DOOSAN Document Transmittal Upper Trishuli-1 HEP (216MW)	Date 2023-07-19	DT No.: UT1-HEP-DHI-PC-D-0196	SHEET 1 OF 1

Contractor	**Doosan Enerbility**		
Title of the Document	Monitoring Layout Drawing of Desander Basin & Design Change Notification		
Document No.	UT1-C-845-CVL-DG-70011 & DCN-23-C-008	Revision	1A
Date of Documents	17.07.2023	Received Date	17.07.2023
Transmittal Form No.	UT1-HEP-DHI-D-0886		
Previous Review Date/Status	17.07.2023/FC	Prev. Review Note No.	N/A
Review Note No.	**RN-0739**	**Present Review Date**	**18.07.2023**
		Present Review Status	**A**

DOOSAN	Design Change Notice	DCN No. **DCN-23-C-008**
	UPPER TRISHULI-1 HEP (216MW)	GRADE: A
		PAGE: 1 OF 2

REFERENCE DOCUMENT NO.	REV	REMARKS / TITLE
UT1-C-845-CVL-DG-70011	1A	Monitoring Layout Drawing of Desander Basin

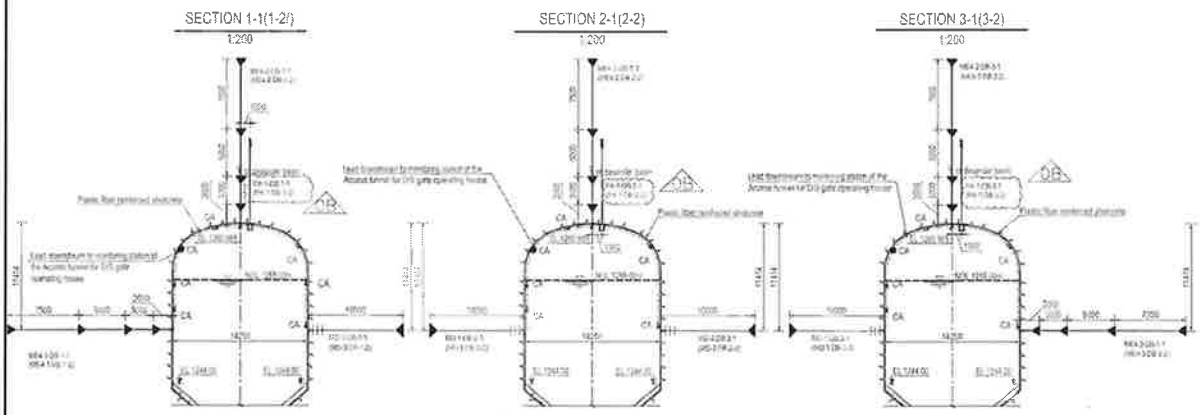
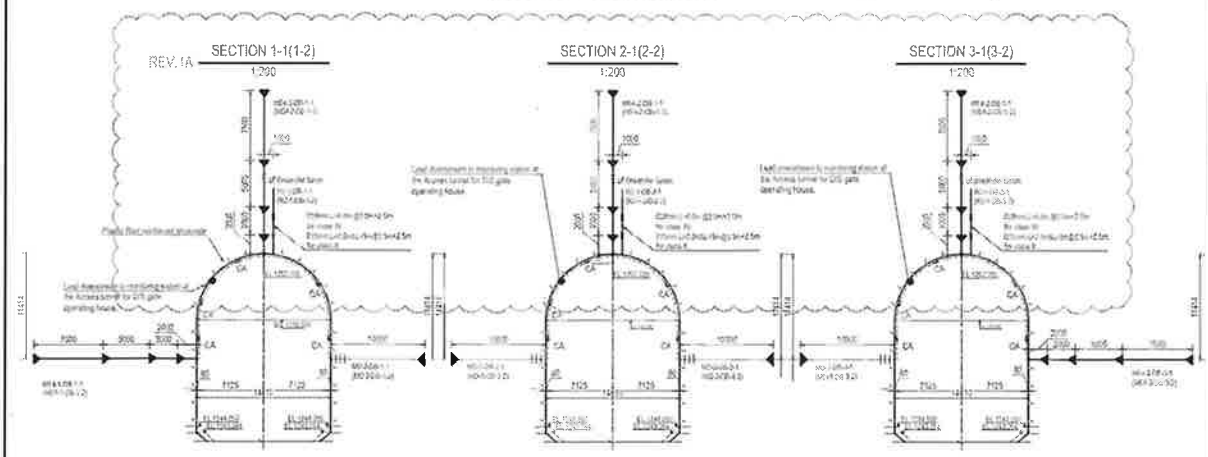
In the latest drawing of the Desander Basin, the crown has already been incorporated as per DCN-22-C-029. Therefore, we have updated the monitoring drawing of the Desander Basin to correspond with the latest layout. In addition, as per the latest excavation and support for the Desander Basin, rock bolts have been replaced with rock dowels. As a result, anchor dynamometers (load cells) have been replaced with two-point anchor bar stress meters in the latest revision.

1. Anchor dynamometer (load cell) is replaced with a two-point anchor bar stress meter.
2. Desander Basin Crown portion is incorporated as per DCN-22-C-029.
3. Please refer to drawing in more detail.
